November 24, 2021

Subject: George Hall Elementary School HVAC Replacement
San Mateo - Foster City School District
Aedis Project No. 2021005.02
DSA Application #01-119523

ADDENDUM NO. 1

DATE 10/04/2021
JOB # 2021005.02
SHEET # AD1-A2.02

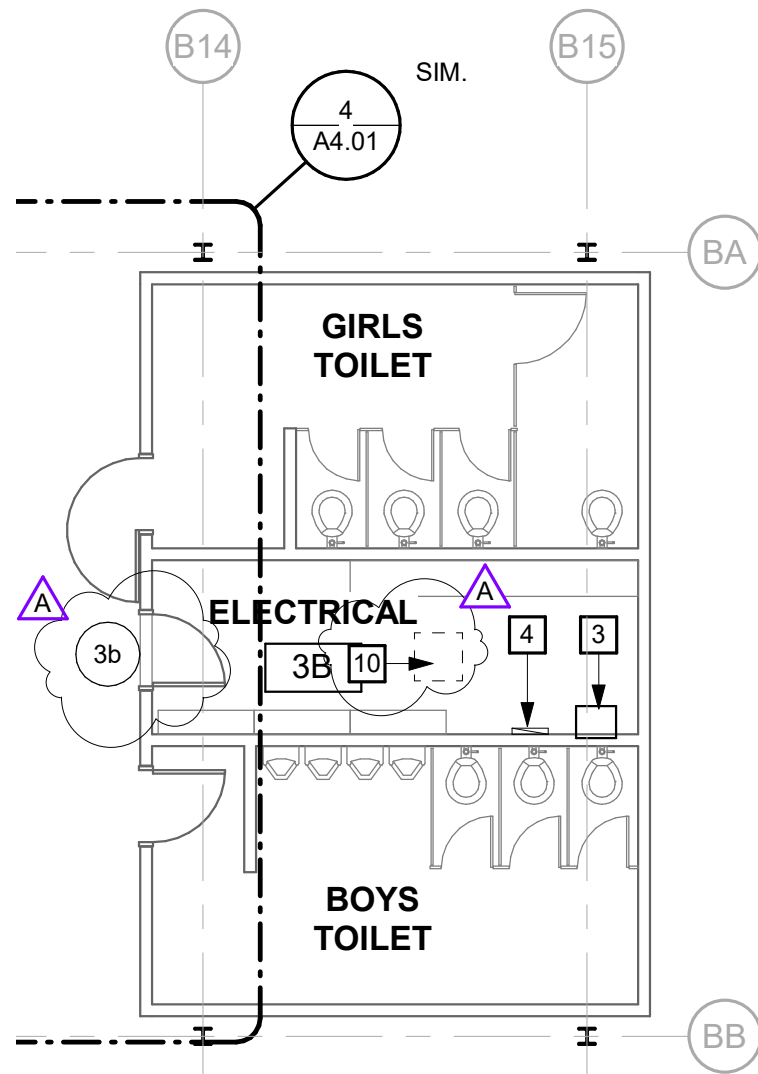
Revise: Floor Plan Keynote #6 locations per AD1-A2.02

Add: General Sheet Note #J per AD1-A2.02

aedis architects		GEORGE HALL ELEMENTARY SCHOOL - HVAC REPLACEMENT	
		SAN MATEO-FOSTER CITY SCHOOL DISTRICT	
387 S. 1st Street, Suite 300 San Jose, CA., 95113 tel: (408) 300 - 5160 fax: (408) 300 - 5121	FILE NO.:	41-26	SHEET AD1-3.01
	APPL NO.:	01-119523	
	JOB NO.:	2021005.02	
		DATE	11/24/2021

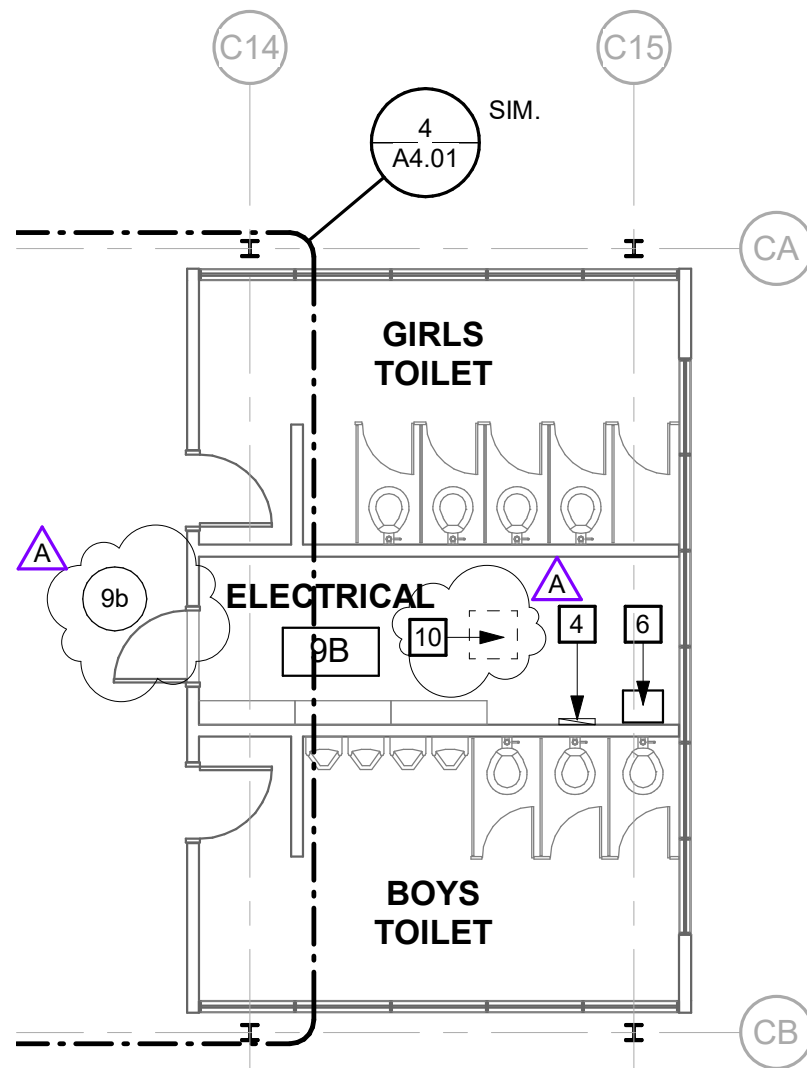
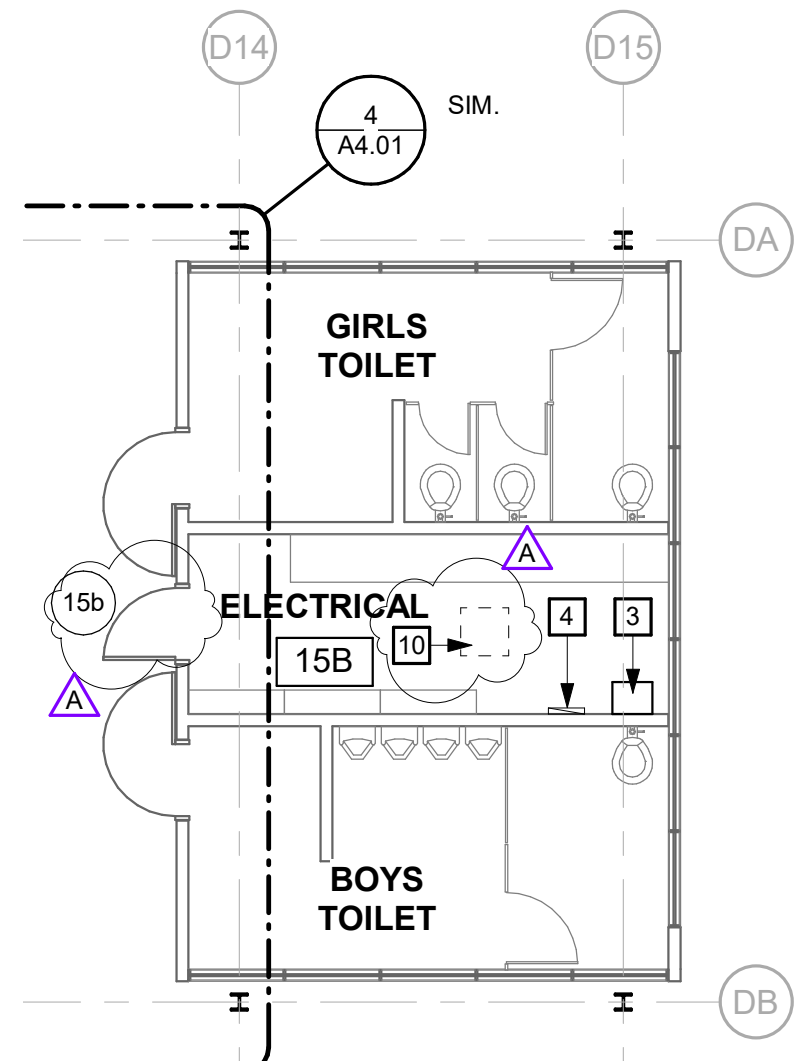
Add: Door tags 3b, 9b & 15b to New Floor Plans 2/A3.01, 3/A3.01, and 4/A3.01 per AD1-A3.01

Add: Ceiling patching keynote #10 to New Floor Plans 1/A3.01, 2/A3.01, and 3/A3.01 per AD1-A3.01

Revise: New Floor Plan Keynotes #8 & #9 per AD1-A3.01

SHEET # AD1-
A5.01

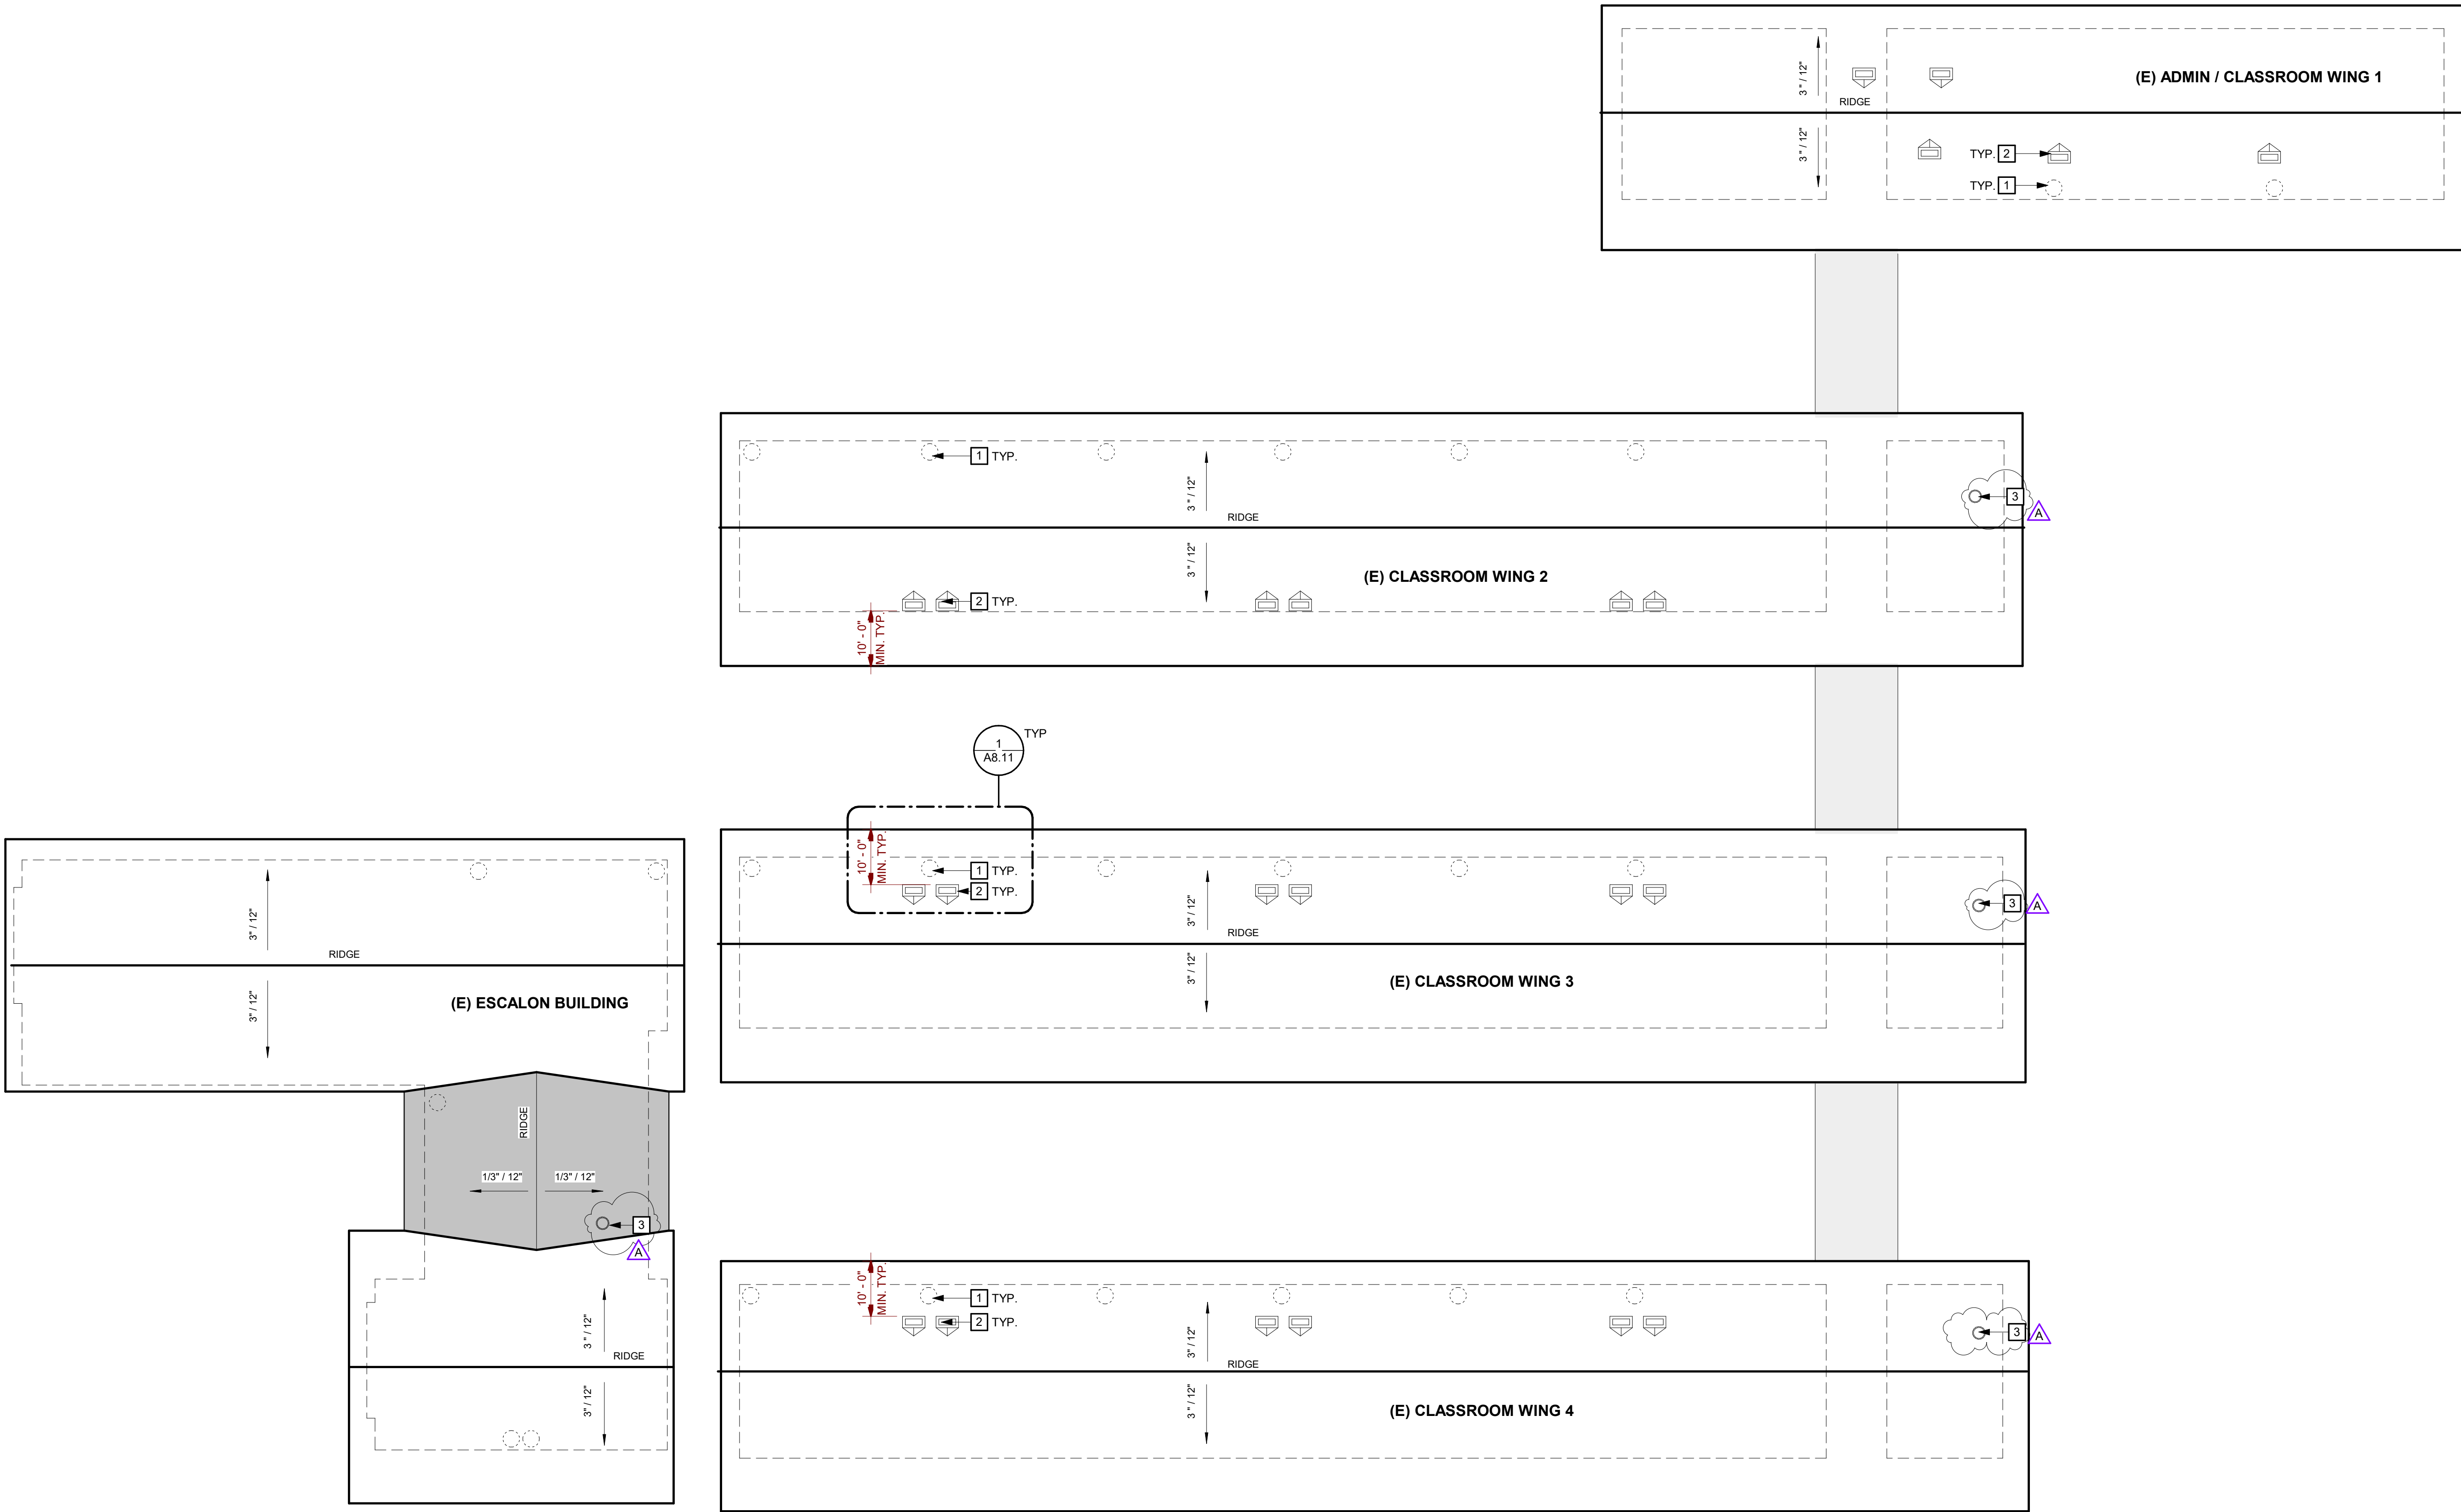
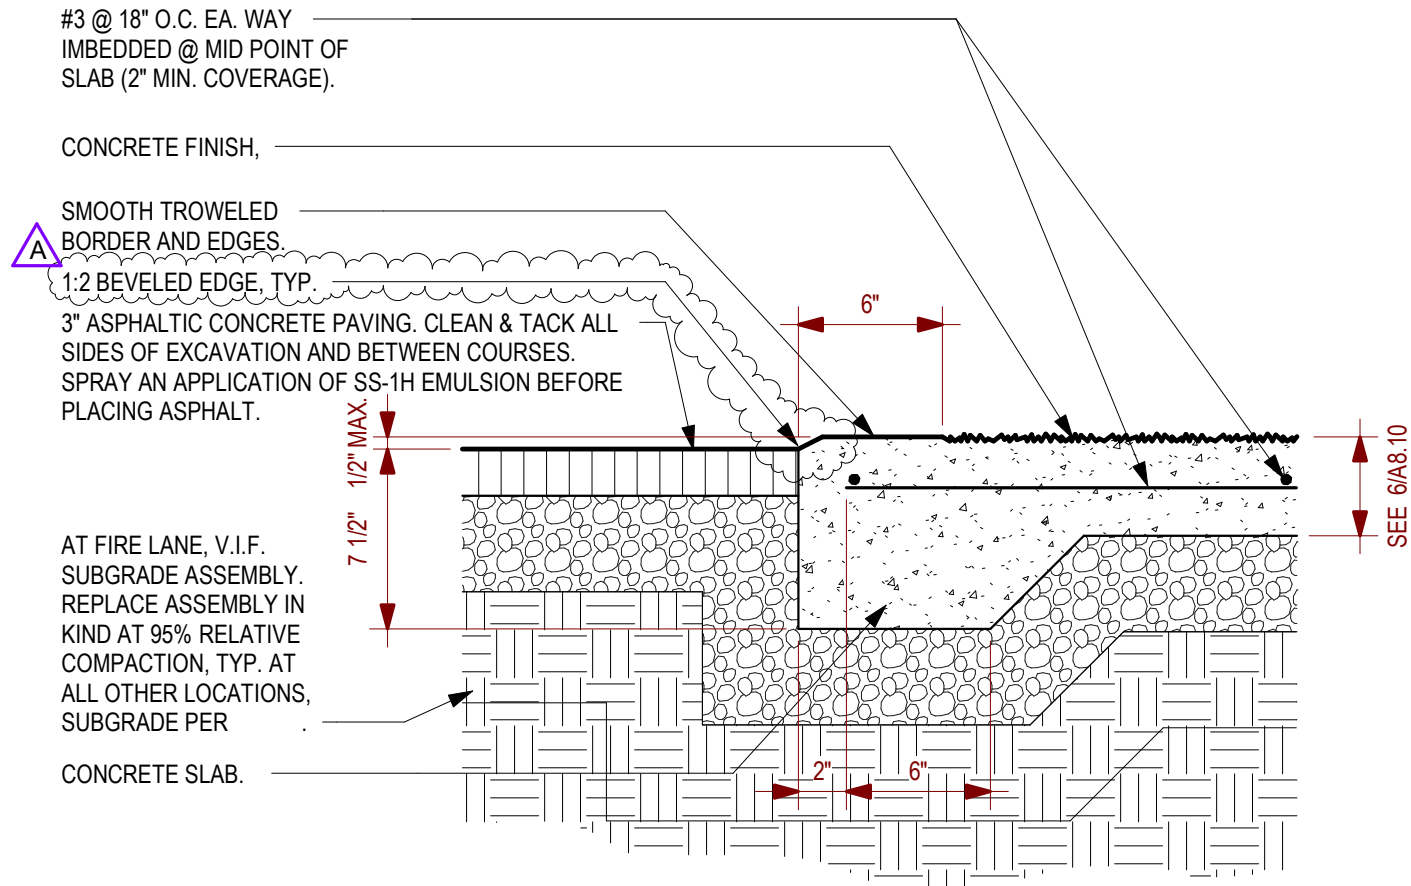
Add: Exhaust fans per AD1-A5.01

Add: Partial Site Roof Plan Keynotes #3 per AD1-A5.01

Revise: Partial Site Roof Plan Keynotes #2 per AD1-A5.01

GEORGE HALL ELEMENTARY SCHOOL - HVAC REPLACEMENT SAN MATEO FOSTER CITY SCHOOL DISTRICT	
		FILE NO.: 41-26 APPL NO.: 01-119523 JOB NO.: 2021005.02 DATE: 11/24/2021	SHEET AD1-A8.10

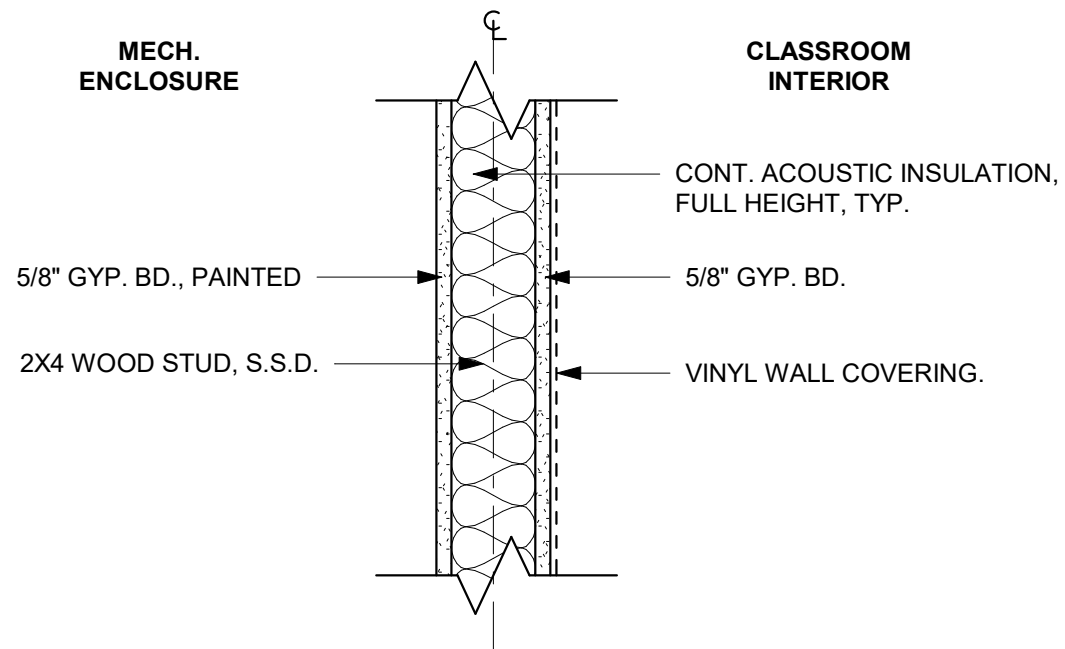
Revise: Detail 9 Asphalt/Concrete Joint per AD1-A8.10

GEORGE HALL ELEMENTARY SCHOOL - HVAC REPLACEMENT	
		SAN MATEO-FOSTER CITY SCHOOL DISTRICT	
FILE NO.:	41-26	SHEET	
APPL NO.:	01-119523	AD1-A9.10B	
JOB NO.	2021005.02		
DATE	11/24/2021

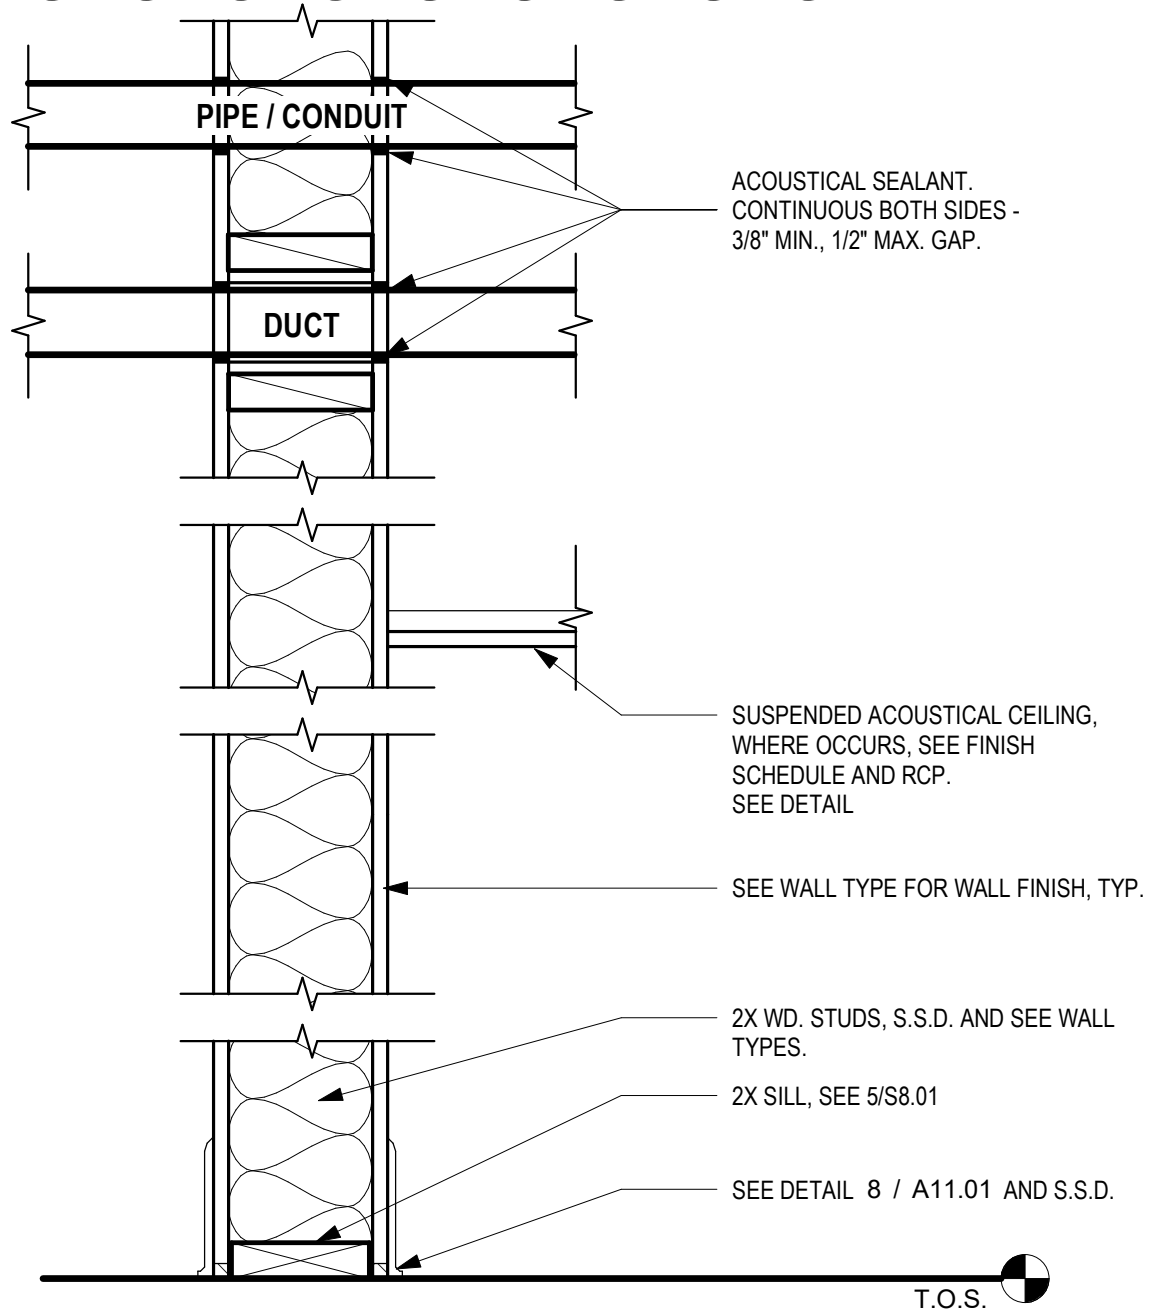
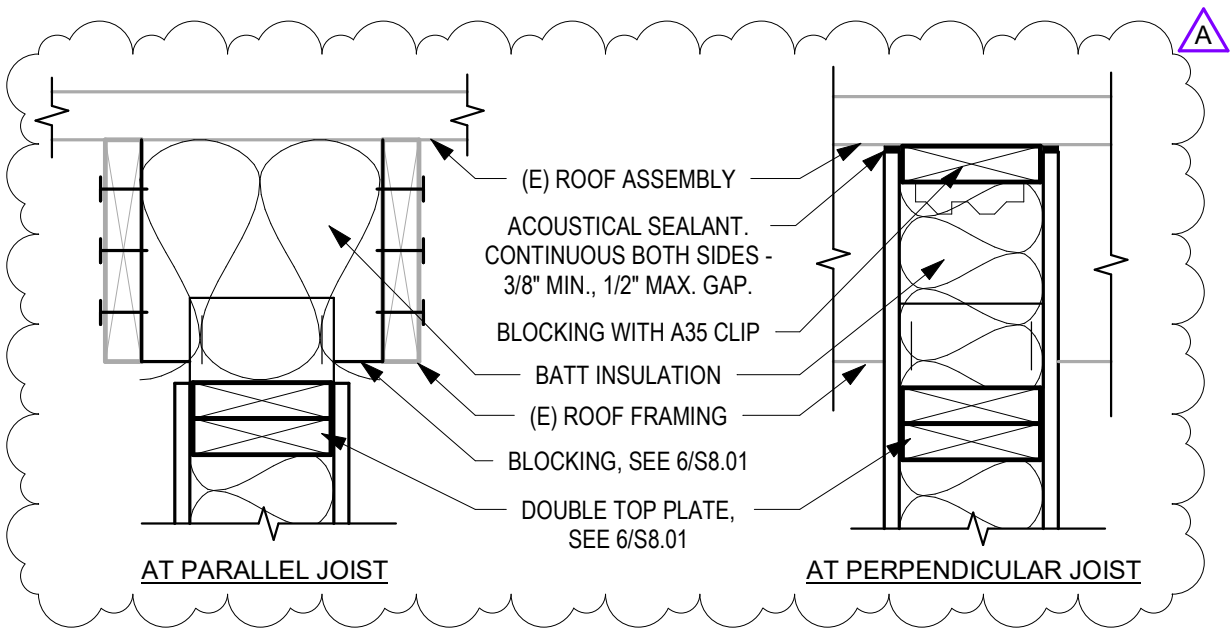
Revise: Detail 6 per AD1-A9.10b
